# Access Compliance Report

## Public Rights-of-Way

### (Curb Ramps)

Intersection ID: N/A	Main Street: HOOVER_CREEK_BV	Cross Street: N/A	Location: NE
ADA ID: 4A8AB7C5894C	Ramp Type: PerpDiag	Initial Pass/Fail: Fail	Overall Compliance: No
Severity Score: 8.75			
Codes/Mitigation Info/Possible Solution		Field Measurements/Component Compliance

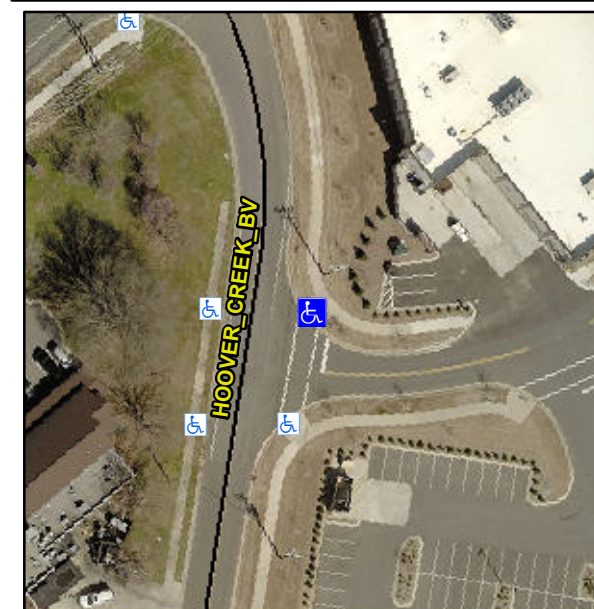
**Not Found, R304.5.1**

Compliance	Description	Data	Compliance	Description	Data
N/A	Ramp Length (in)	95.0	Yes	Ramp Slope (%)	7.9
No	Ramp Width (in)	44.0	Yes	Ramp XSlope (%)	0.8
N/A	Flare Type LT	N/A	N/A	Flare Type RT	N/A
N/A	Flare Slope LT (%)	N/A	N/A	Flare Slope RT (%)	N/A
N/A	Flare Traversable LT?	N/A	N/A	Flare Traversable RT?	N/A
N/A	Landing Length (in)	N/A	N/A	DWS Provided?	N/A
N/A	Landing Width (in)	N/A	N/A	DWS Contrast?	N/A
N/A	Landing Slope (%)	N/A	N/A	DWS Length (in)	N/A
N/A	Landing X Slope (%)	N/A	N/A	DWS Full Width?	N/A
N/A	Landing Curb? (Y/N)	N/A	N/A	DWS Offset (in)	N/A
N/A	Shared Landing?	N/A			
N/A	Gutter Ponding?	N/A	N/A	Gutter Slope (%)	N/A
N/A	Gutter Lip Ht (in)	N/A	N/A	Gutter X Slope (%)	N/A
N/A	Painted X Walk1?	No	N/A	Painted X Walk2?	Yes
	X Walk 1 Direction	To NW		X Walk 2 Direction	To SW
N/A	X Walk 1 Width (in)	N/A	N/A	X Walk 2 Width (in)	122.0
	X Walk 1 Slope (%)	0.6		X Walk 2 Slope (%)	1.3
	X Walk 1 X Slope (%)	2.5		X Walk 2 X Slope (%)	0.5

**Remove & Replace Curb Ramp With Two New Directional Ramps or Equivalent.**
